TO: T10 Membership
FROM: Paul A. Suhler, Quantum Corporation
DATE: 30 January 2009
SUBJECT: T10/08-409r7, ADT-2: Internet ADT (iADT)

Changes to ADT-2 rev. 5

Figure 34 — Example Media Changer application of ADT

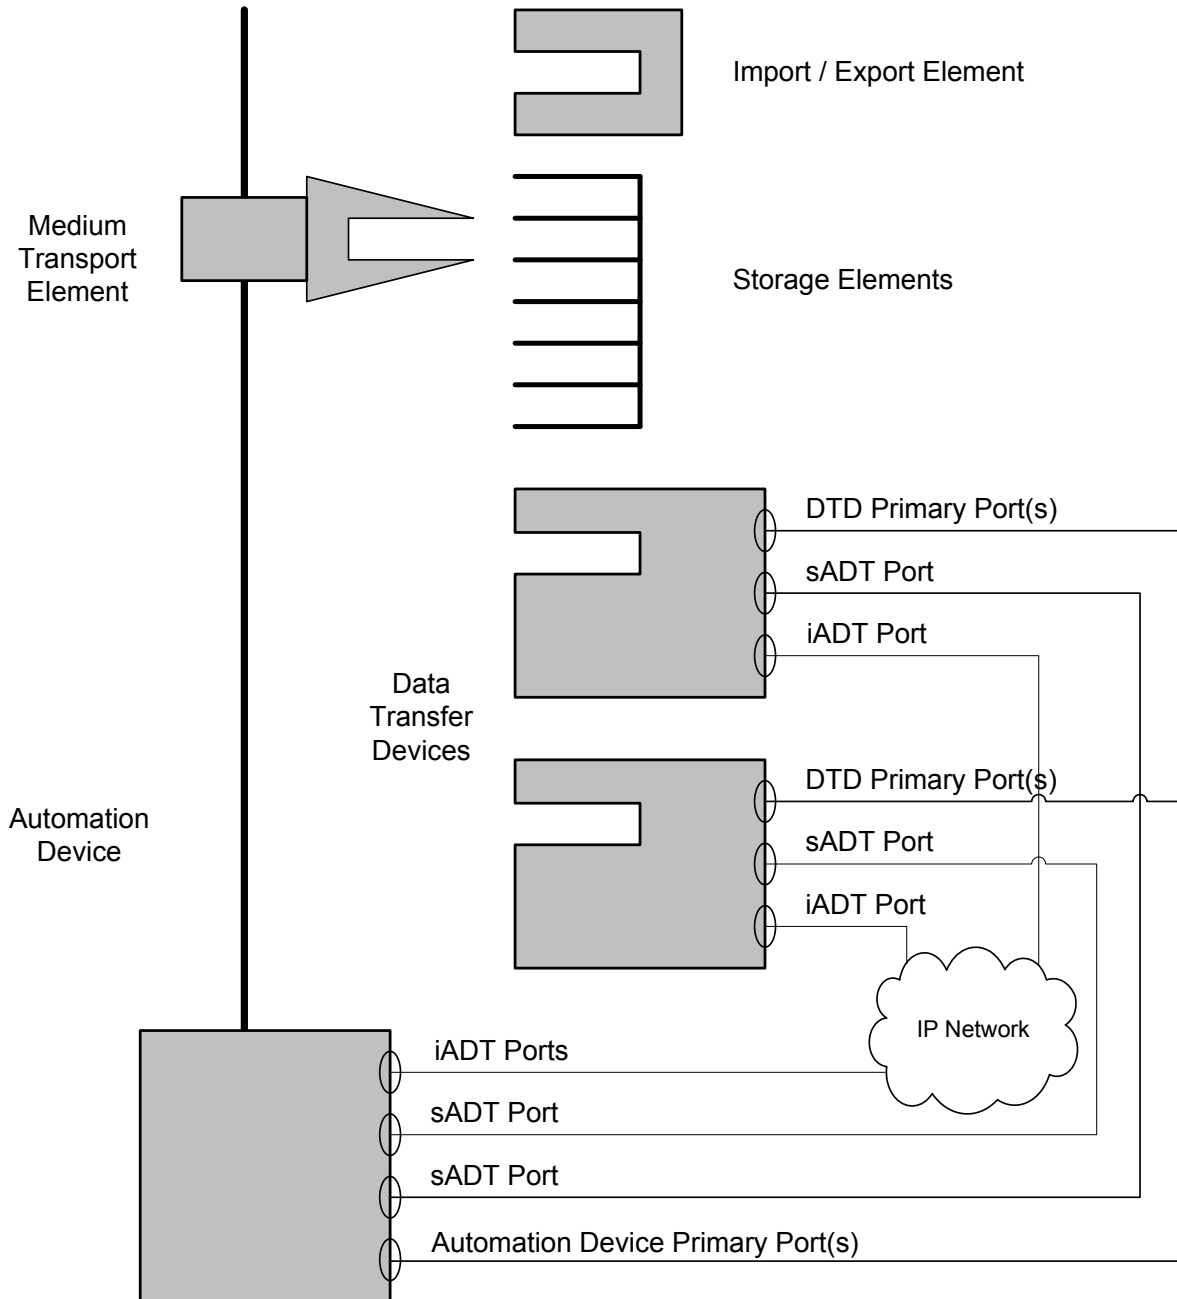
Figure 3 4 shows ~~an example of an ADT interface~~ examples of serial ADT (sADT) and internet ADT (iADT) interfaces (see 4.1.2) within a media changer containing two DT devices. Other common components of a media changer are also shown for reference. The components of an automation device are medium transport elements, data transfer (DT) devices, storage elements, and import/export elements (see SMC-3). The automation device may communicate with the DT devices through ADT ports, as defined in this standard. DT devices and automation devices communicate with initiator ports other than those in the automation device using primary ports.

Note: A media changer ~~or DT device~~ would not necessarily ~~use~~ contain both sADT and iADT ports. They are both shown for comparison.

Replace and renumber Figure 3:

4.3.2.5.2 Transition P3:Logged-out to P0:Initial

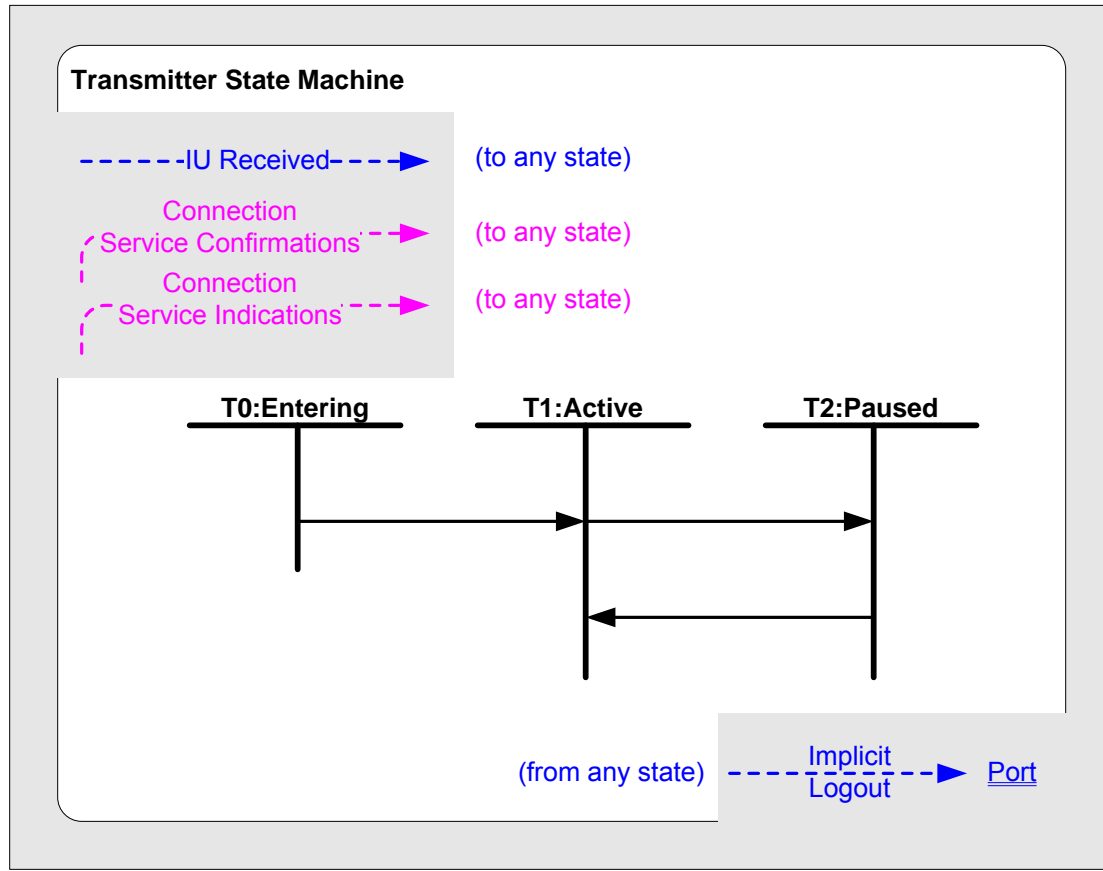
A port shall transition to P0:Initial after the logout duration time ~~specified in the Port Logout IU (see 6.5.5)~~ has expired.

Figure 18a – Connection services for establishing a connection between iADT ports

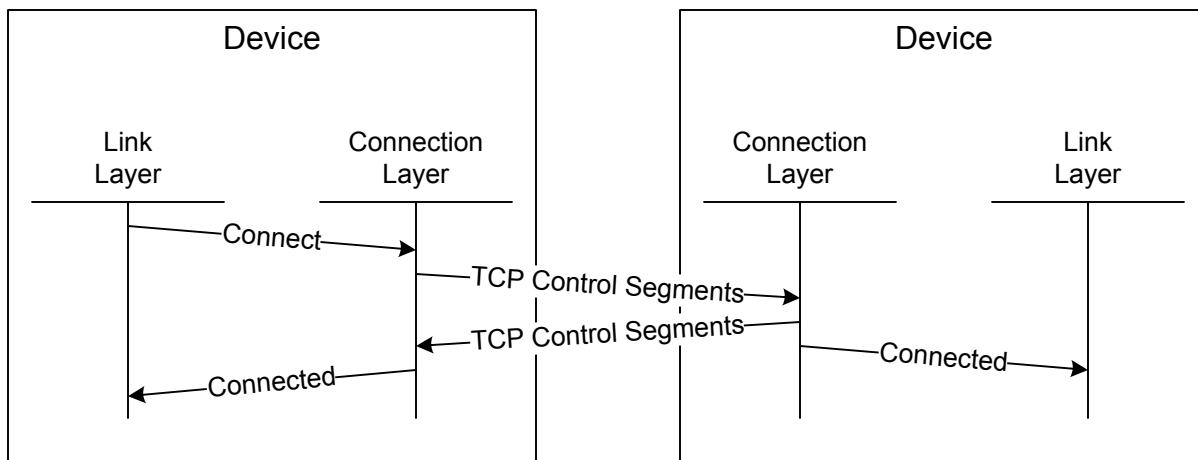
Figure 18a shows an example of the relationships among the connection services used to establish a connection between two iADT ports. The communication between the two devices is defined in RFC 793 and may constitute more than the two communications shown.

Figure 20a – Connection services for closing a connection between iADT ports

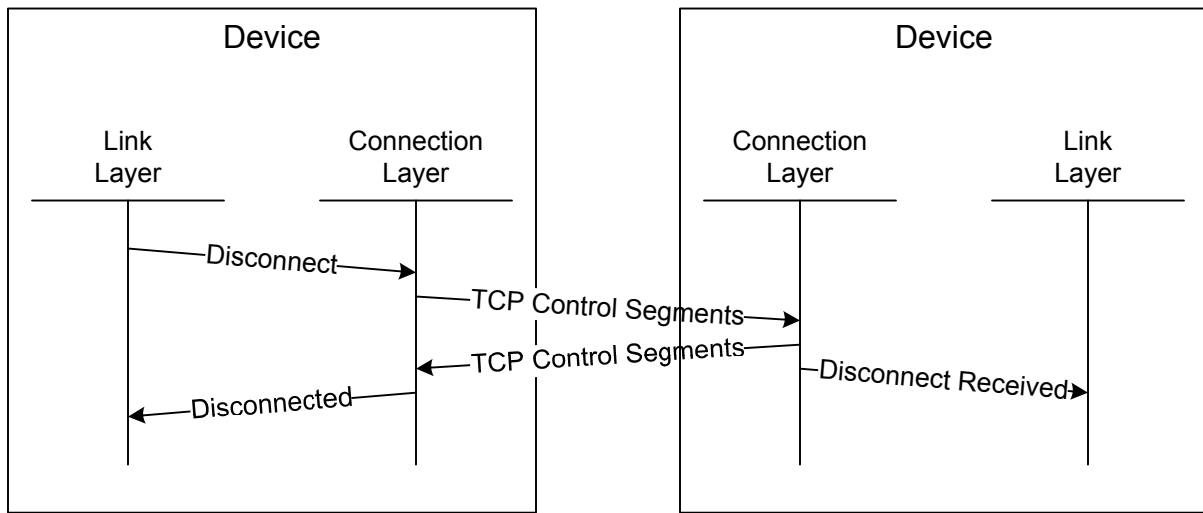
Figure 20a shows the relationships among the connection services used to close a connection between two iADT ports. The communication between the two devices is defined in RFC 793 and may constitute more than the two communications shown.

An iADT port link layer closes a connection by invoking the **Disconnect** service request. An iADT port shall attempt to transmit any characters that have been successfully submitted for delivery by earlier **Send** service requests before the connection is closed. When an iADT port receives a **Disconnected** service confirmation or a **Disconnect Received** service indication, the connection is closed and no more characters shall be received. iADT ports exchange TCP control segments in order to close the connection.

Figure E.6-5 – Duplicate DTD-initiated connections

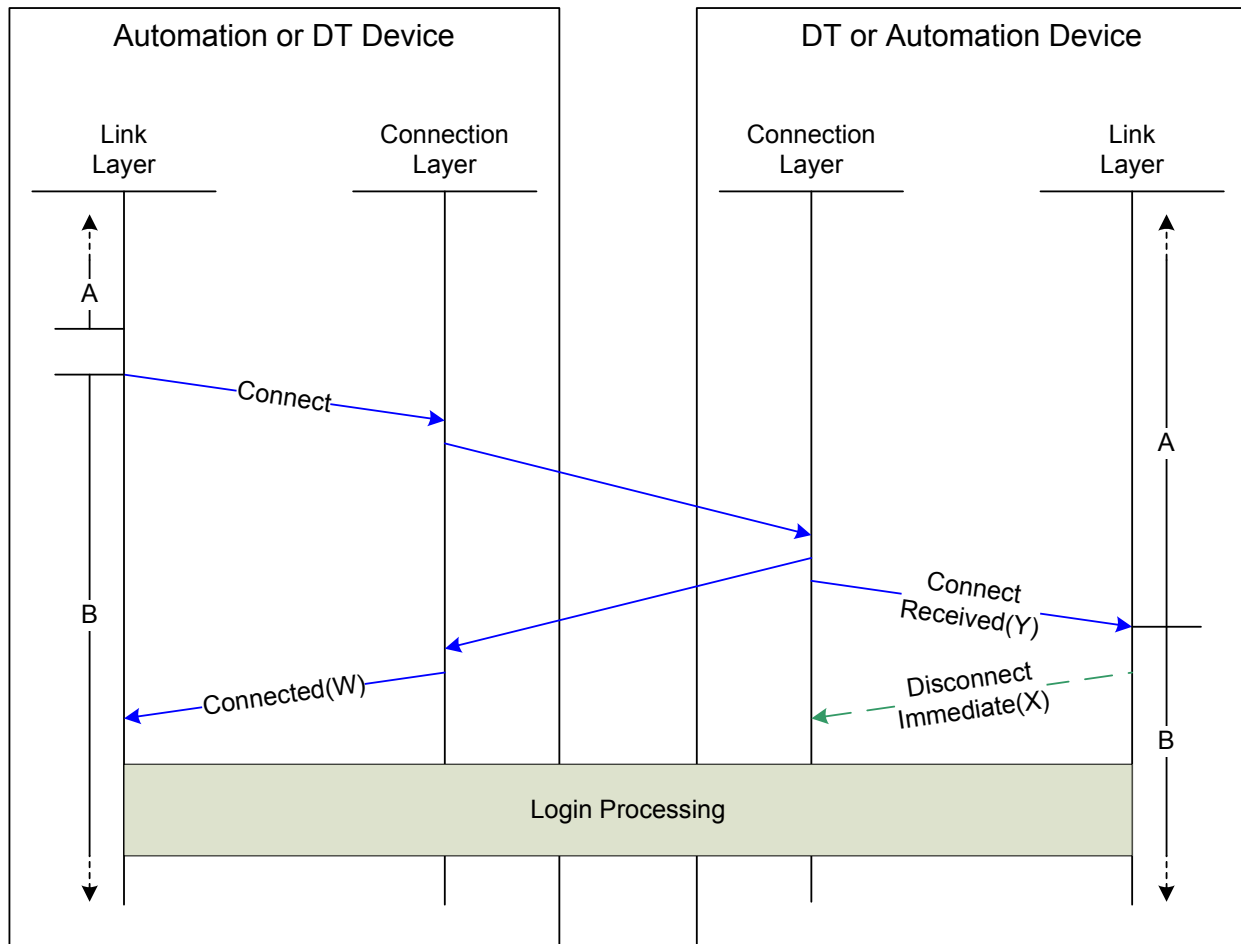
E.65 Duplicate DTD-initiated connections**Connection received in session with established connection**

Figure E.6 shows the case in which one device initiates a connection, login is processed, and the other device initiates a connection without closing the first connection. Following the rules in 7.6, the first connection established is closed. Figure E.5 shows the case in which session A exists in both ports and then unexpectedly ends in one port, requiring establishment of a new session B and a new connection. Following the rules in 7.6, in the port processing the **Connect Received** service indication, session A ends, session B begins, connection Y is established, and the **Disconnect Immediate** service request is invoked to close the previous connection X. In the port initiating the connection, the new connection identifier is W. A new login is then processed.
